Docket No. 52-010

Subject: **Response to Portion of NRC Request for Additional Information Letter No. 319 Related to ESBWR Design Certification Application - RAI 7.1-139**

RAI Number 7.1-139

Figure 7.1-1. **ESBWR Instrumentation and Control** Simplified Network/Functional Block Diagram of DCIS

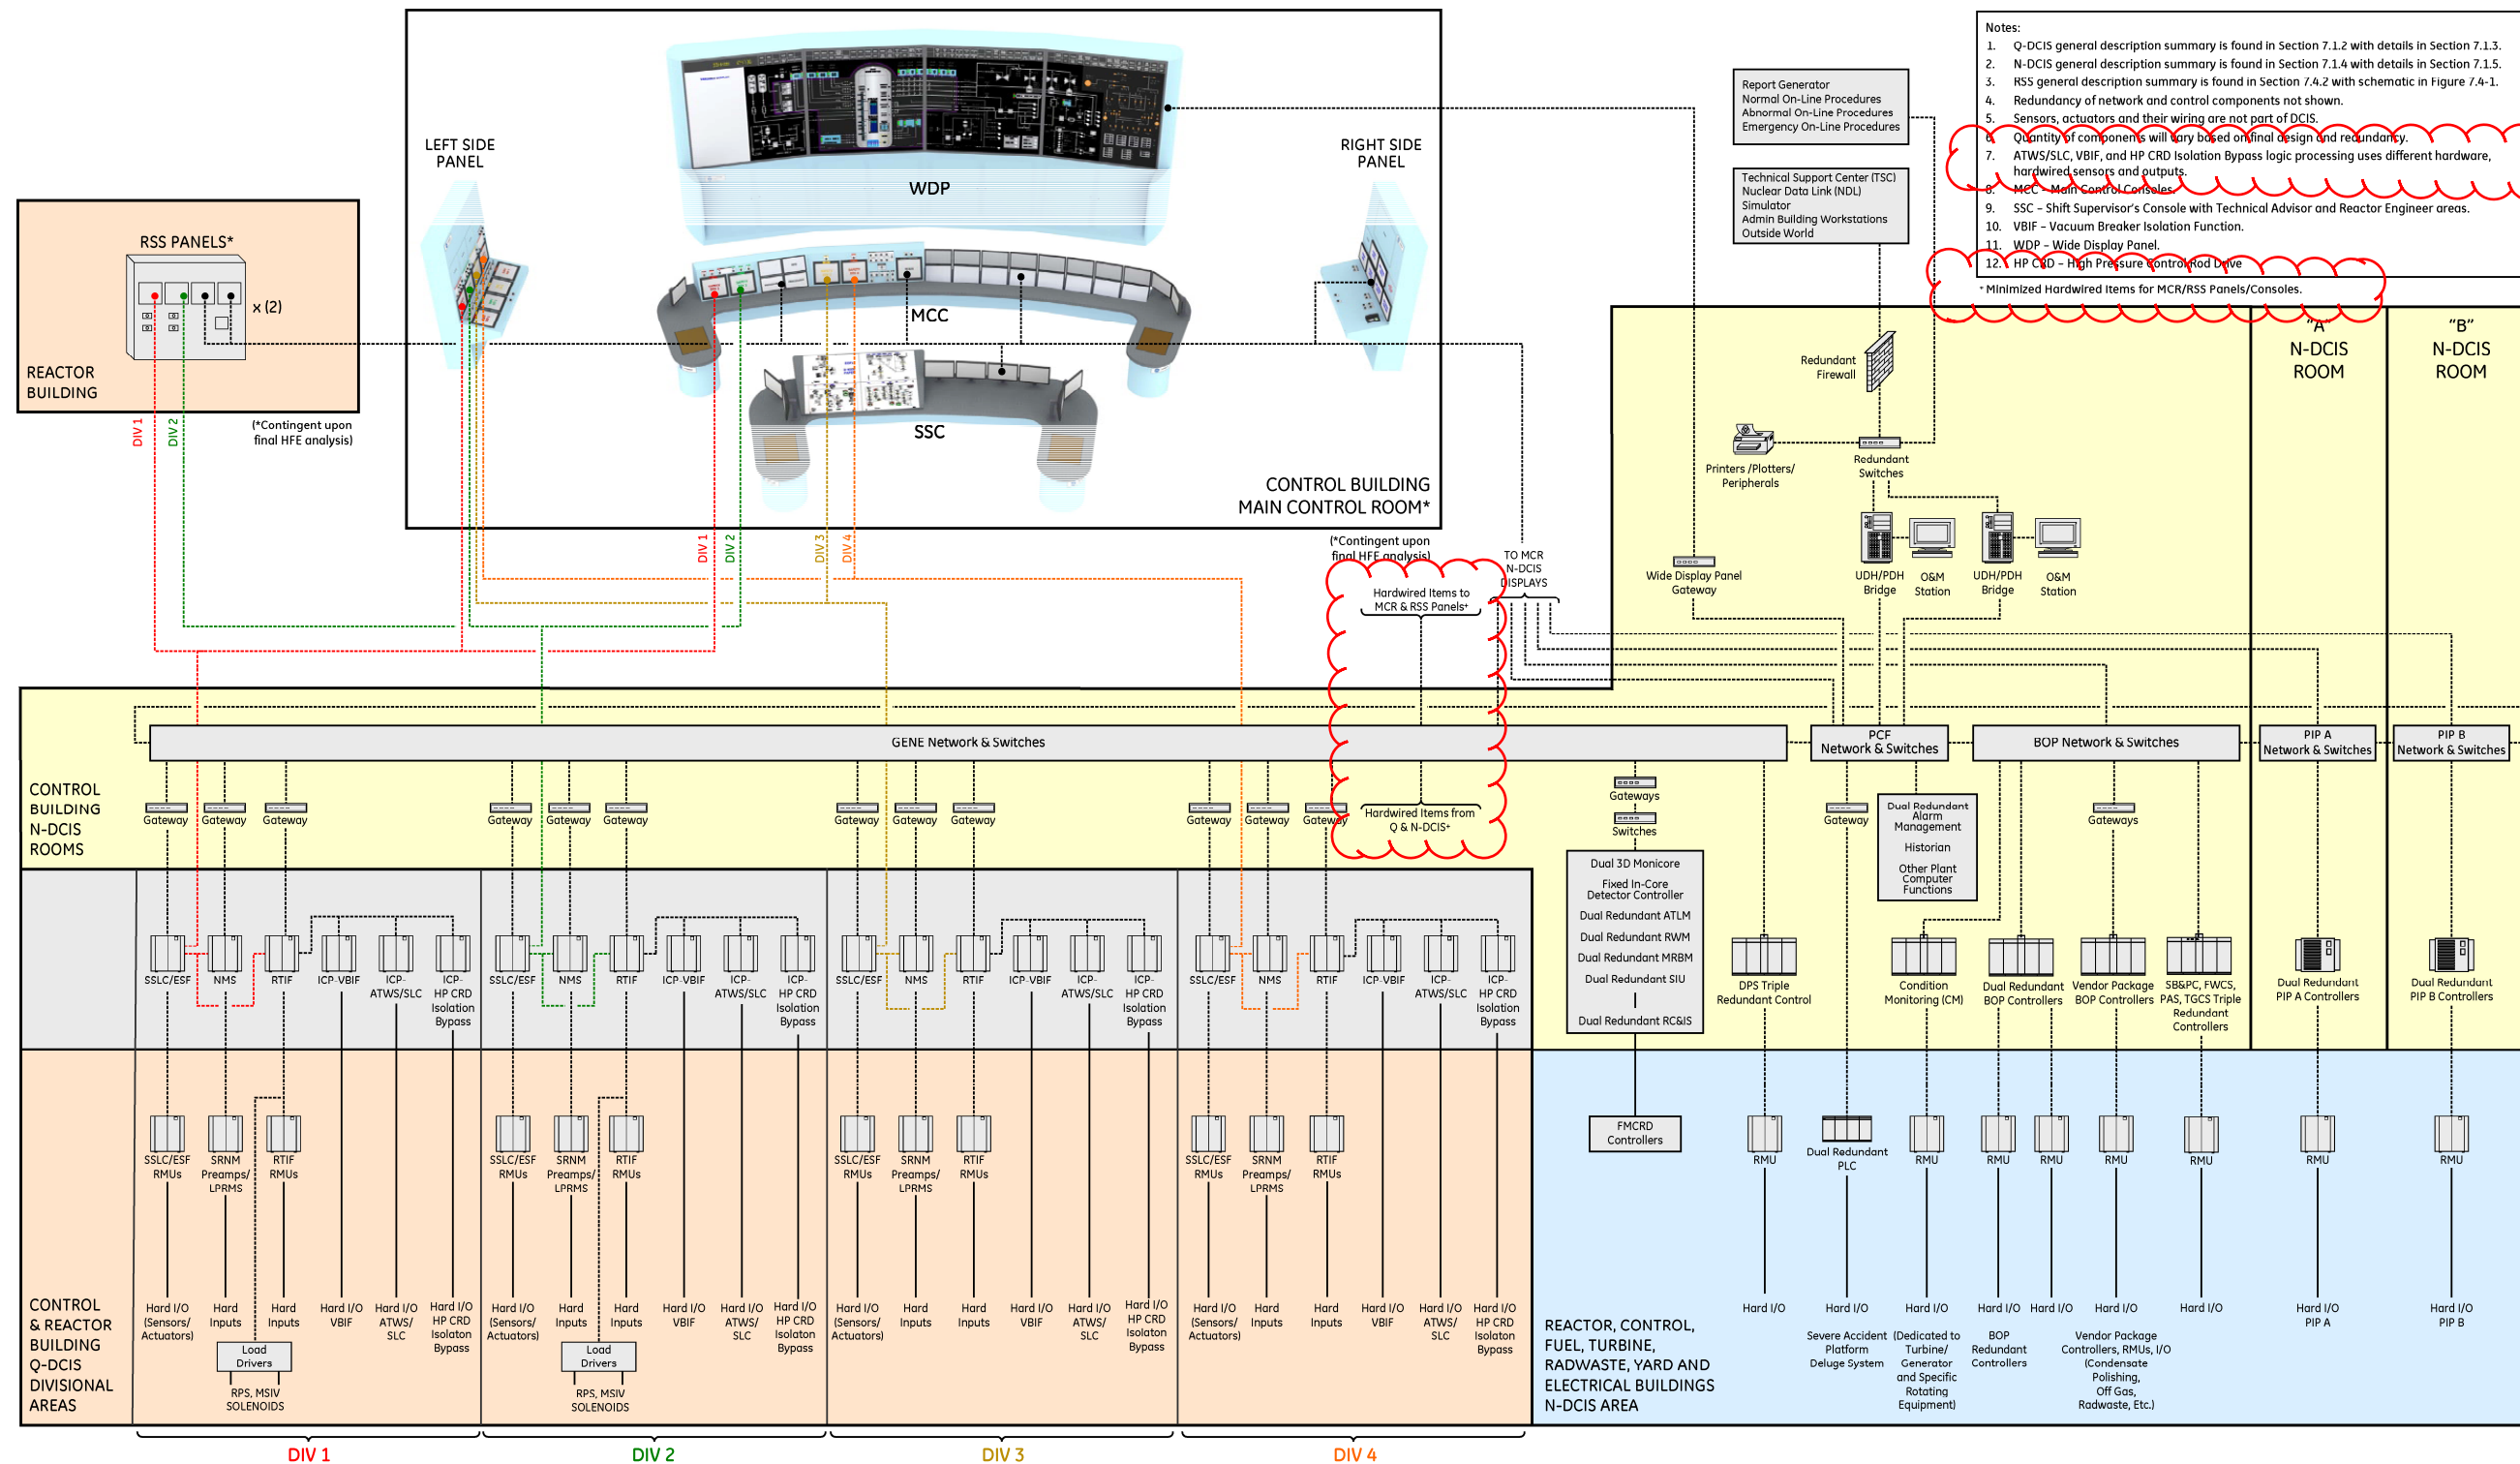
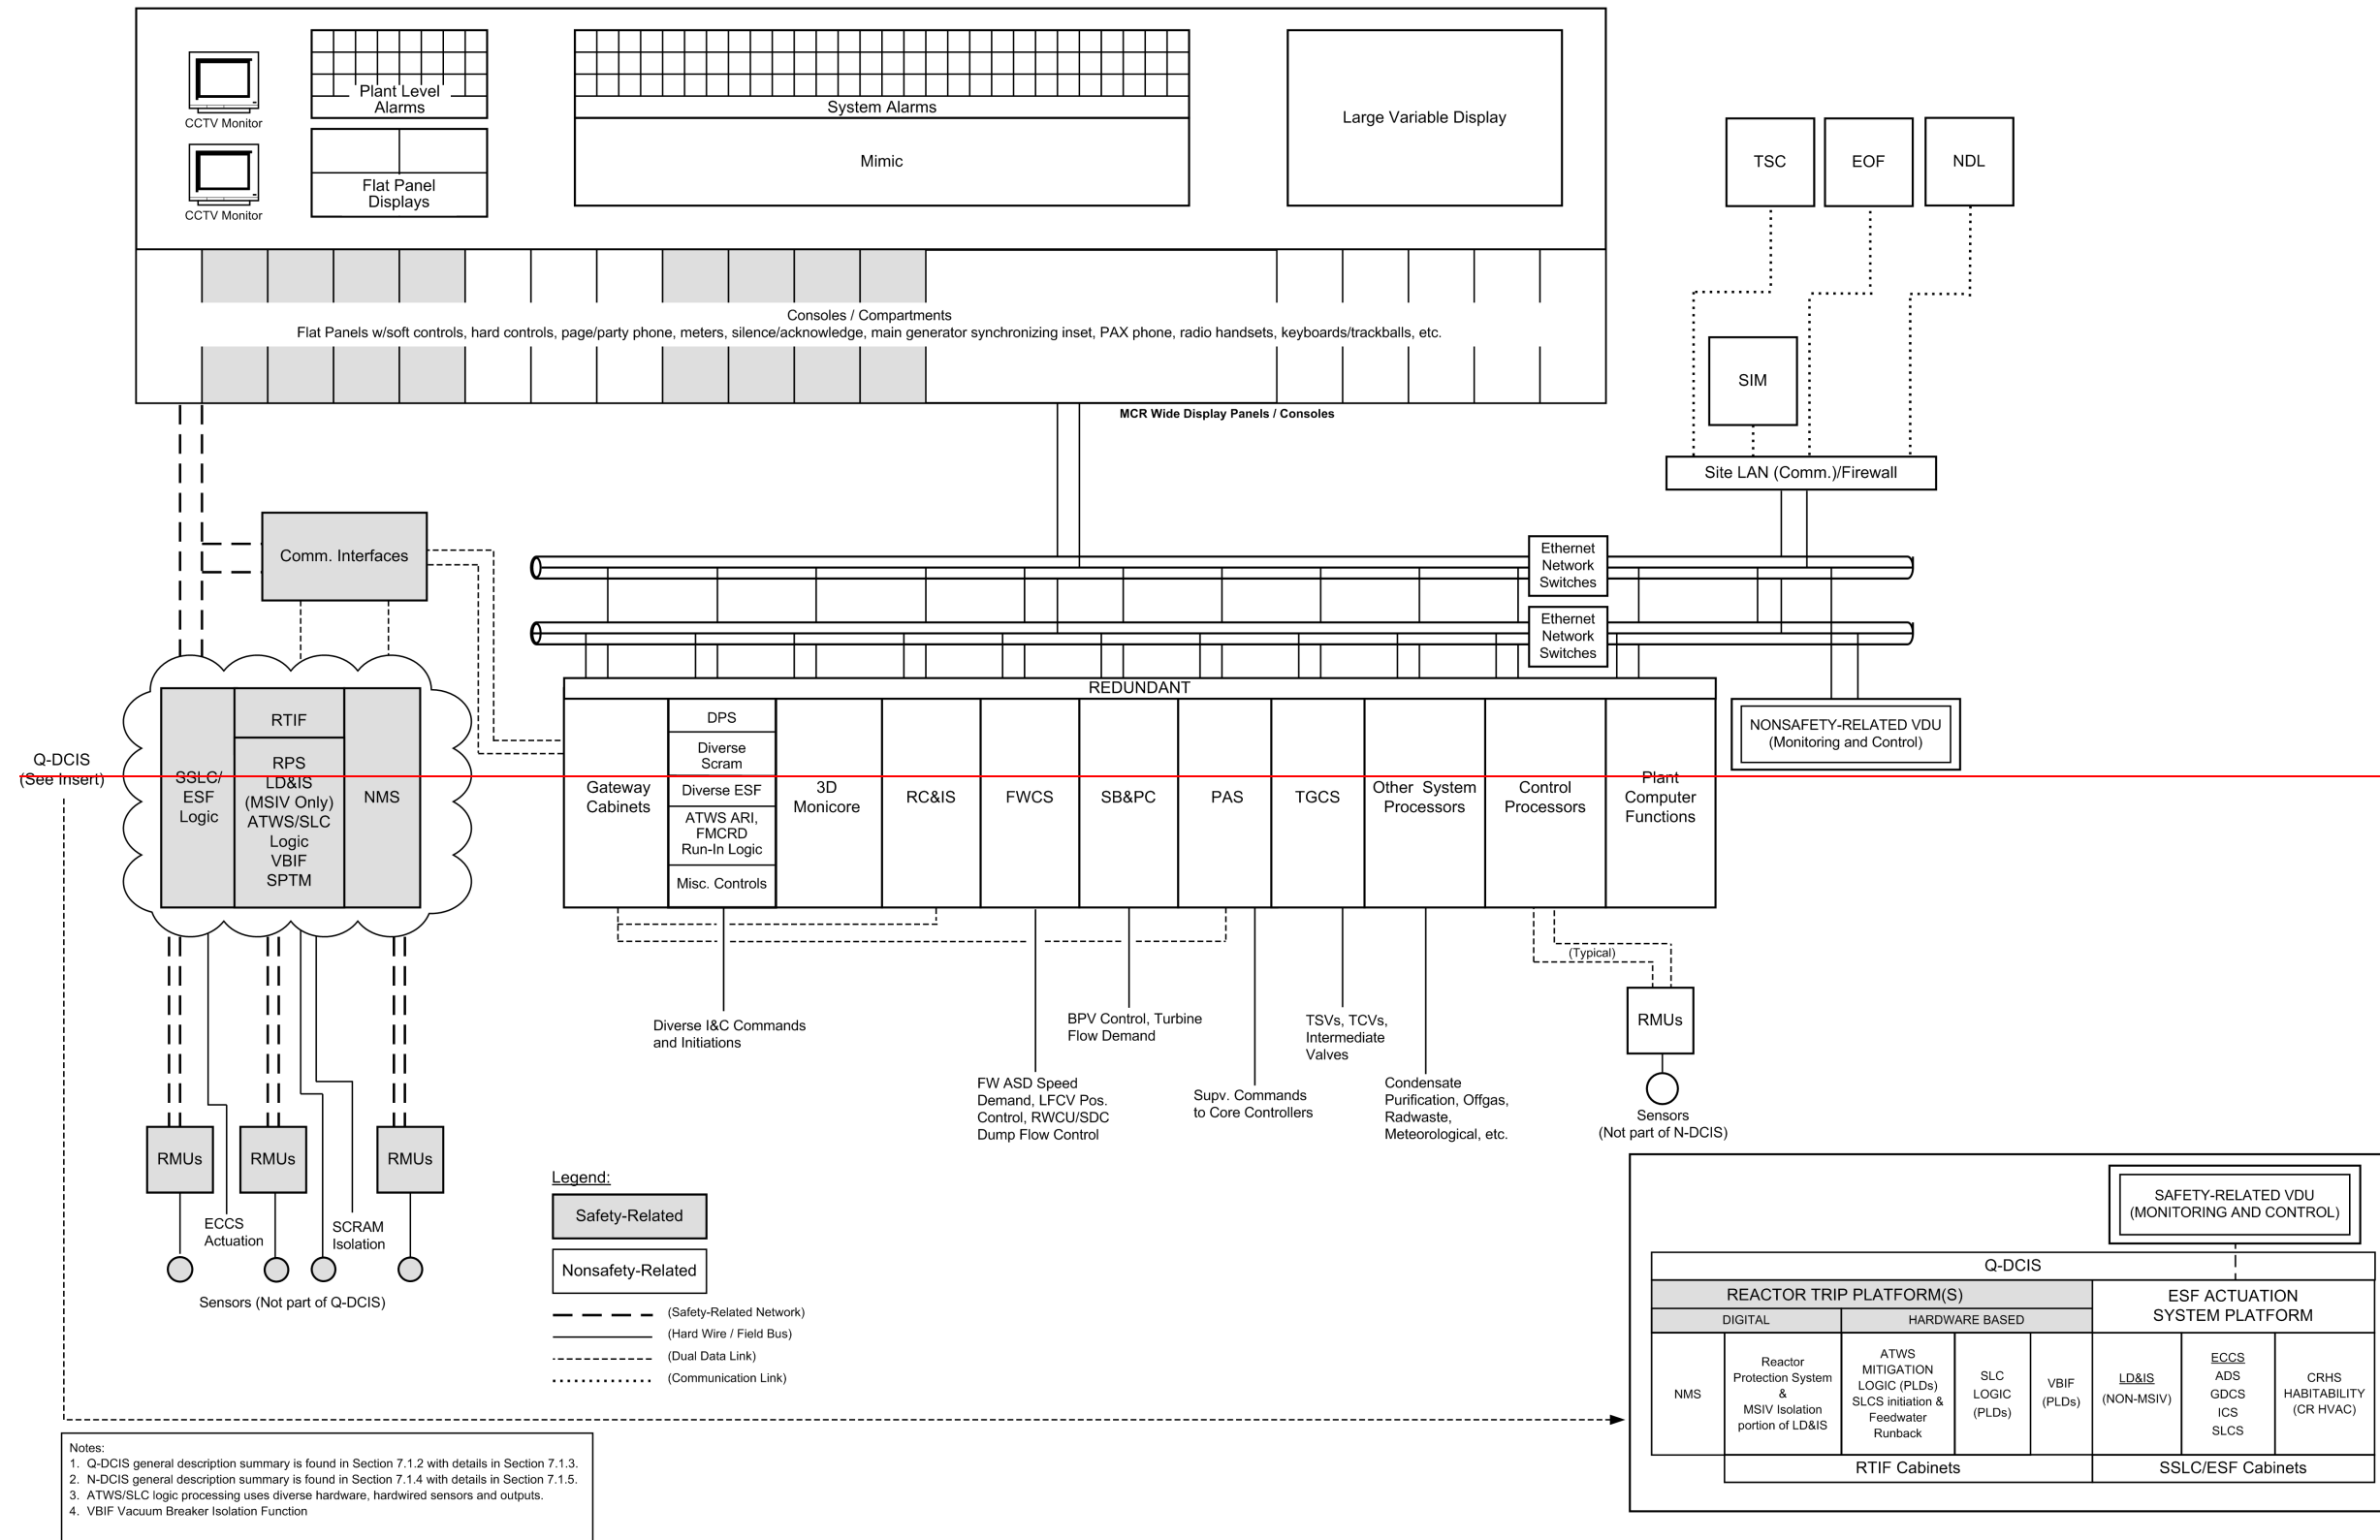
- 3. DCD Tier 2 Figure 7.1-1 shows the elements of the Q-DCIS and the N-DCIS with a very high-level functional representation. During the ACRS meeting, GEH presented additional architectural information, including a simplified diagram with a "safety ring." This level of architectural detail needs to be included in the DCD for the safety systems. Add figures with this level of detail to the DCD with corresponding discussion in the text as applicable.*

3. *DCD Tier 2 Figure 7.1-1 shows the elements of the Q-DCIS and the N-DCIS with a very high-level functional representation. During the ACRS meeting, GEH presented additional architectural information, including a simplified diagram with a "safety ring." This level of architectural detail needs to be included in the DCD for the safety systems. Add figures with this level of detail to the DCD with corresponding discussion in the text as applicable.*

Chapter 7 will be revised to provide revised and additional figures along with corresponding descriptions.

- Figure 7.1-1, Simplified Network/Functional Diagram of DCIS.

Figure 7.4-1. Remote Shutdown System Panel Schematic

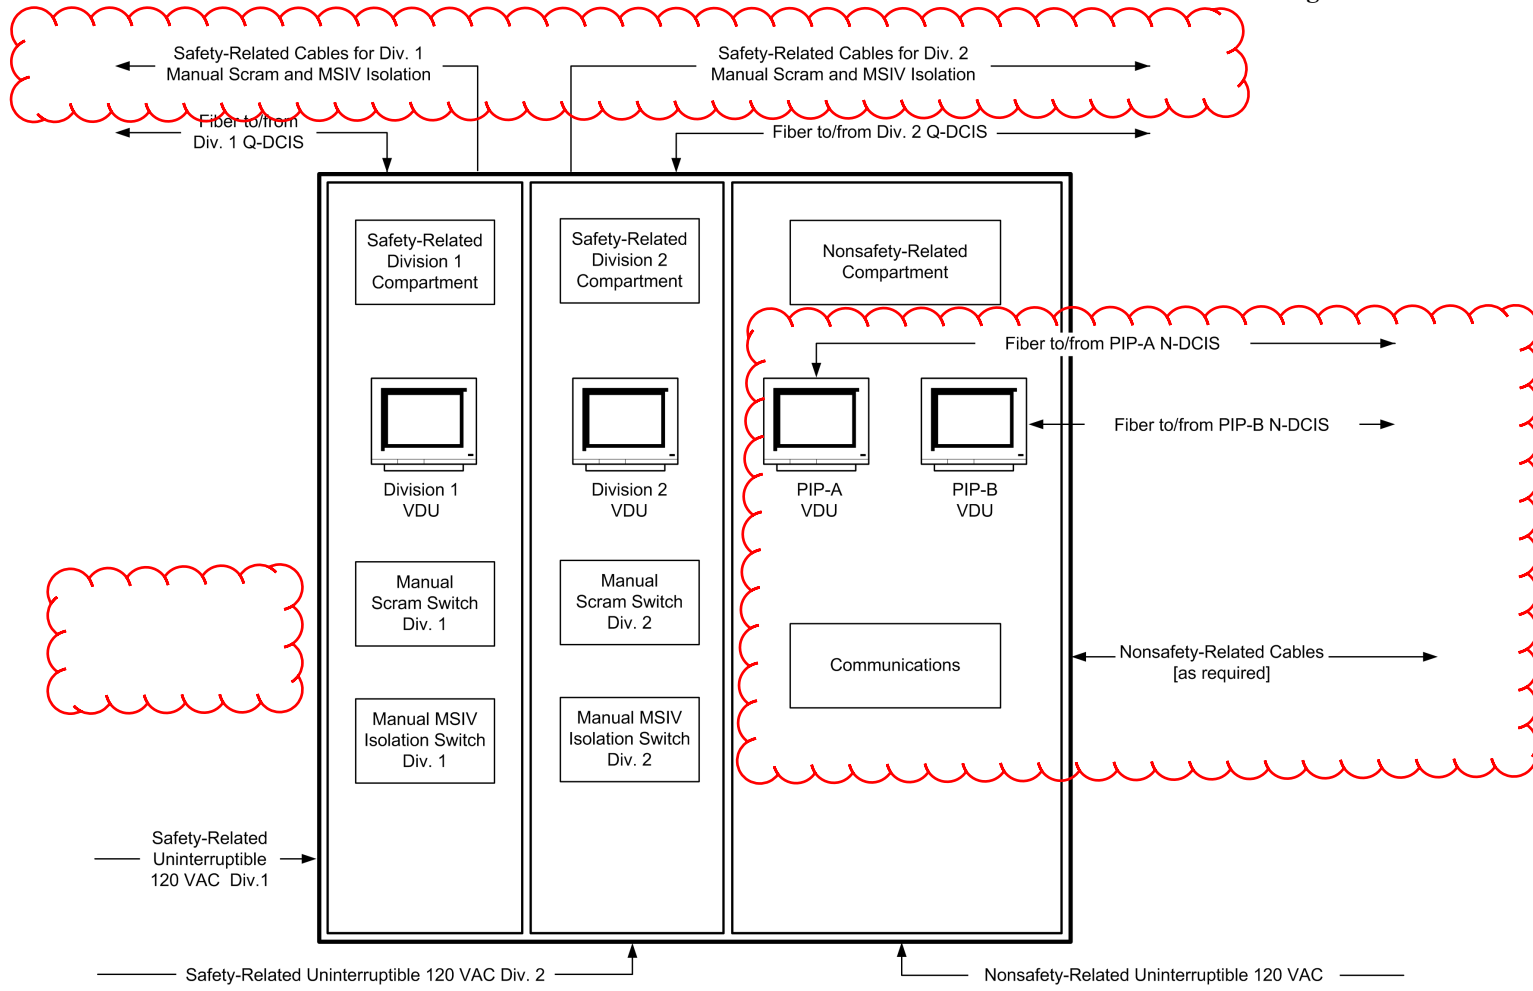
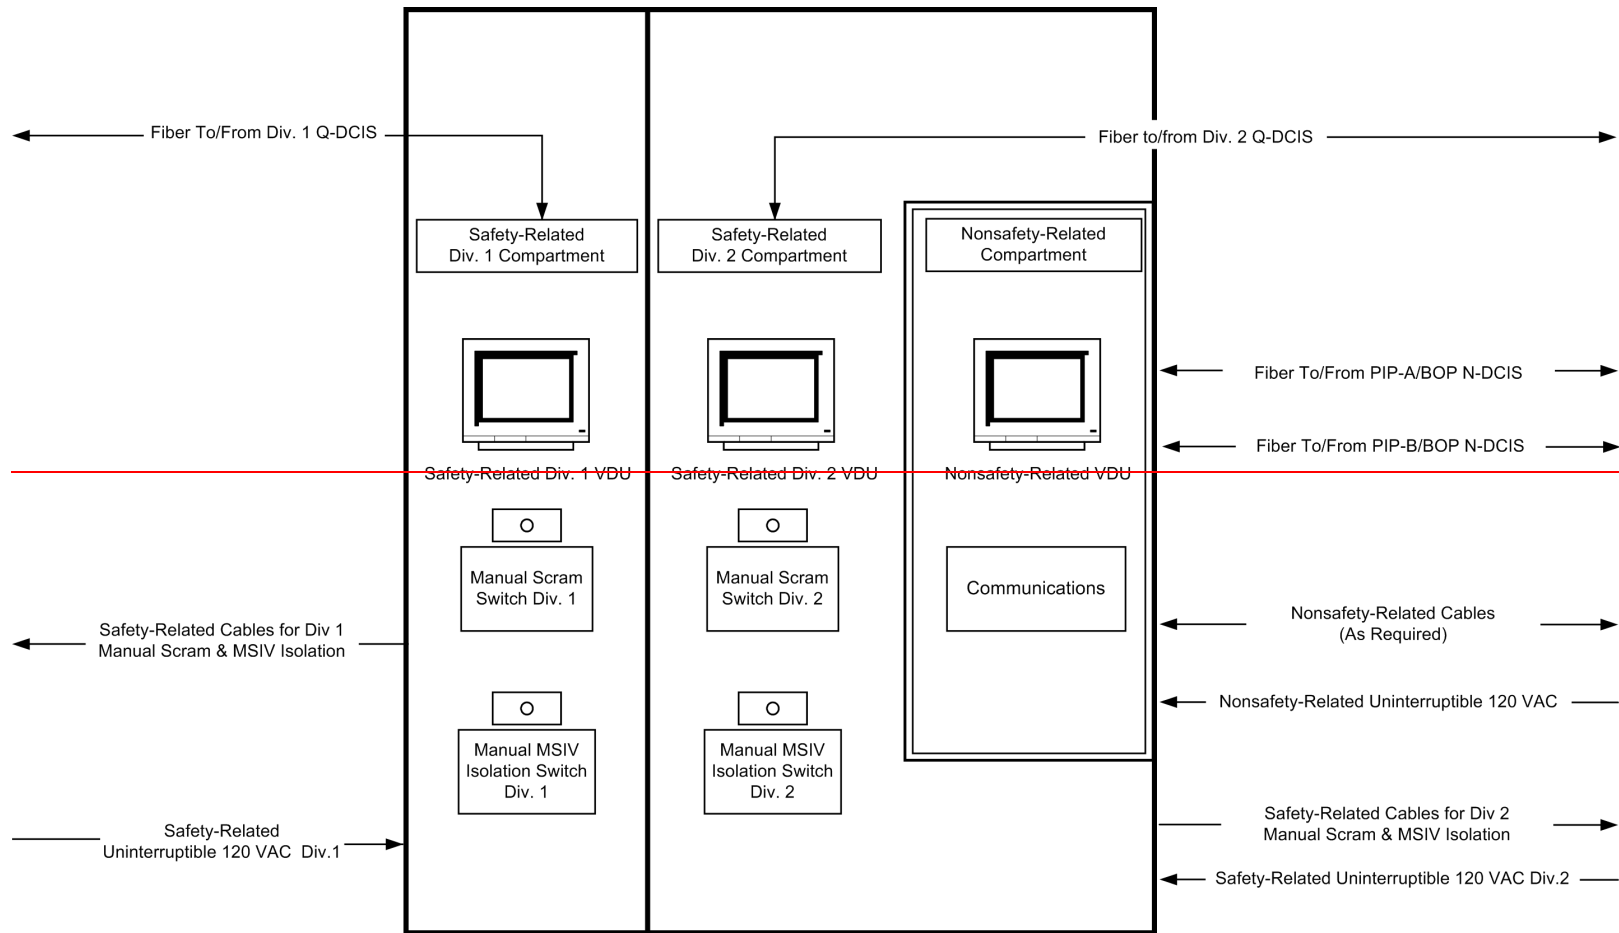
4. *Provide additional clarification in DCD Section 7.4.2.2.2 to describe how plant control is transferred from the main control room to remote shutdown station (RSS). If RSS is normally online and with no operators at the panels, clarify the kind of administrative control will be implemented for these panels.*

Remote Shutdown System (RSS) VDUs panels are connected to Q-DCIS or N-DCIS through the same networks serving VDUs in the MCR. All Division 1 and 2 safety-related and all nonsafety-related data/display/control functions available at the MCR are available at the RSS panels. A simplified RSS panel schematic is provided in Figure 7.4-1. Operator activities related to the transfer of plant control between the main control room and RSS panels are controlled by plant procedures. The task is analyzed and procedures are developed as part of the HFE design process. DAC-ITAAC are provided for the HFE design process (refer to Tier 1, Table 3.3-2, items 3, and 7). Access to the RSS and panels therein will be determined as part of the IEEE-603 Criterion 5.9 analysis (refer to Tier 2, Subsection 7.1.6.6.1.10). DAC-ITAAC are provided for this analysis (refer to Tier 1, Table 2.2.15-2, Item 12).

DCD Tier 2, Chapter 7, subsection 7.4.2.2.1 and Figure 7.4-1 will be revised in Revision 6 to include the two PIP VDUs in the RSS panels, as shown in Enclosure 2.
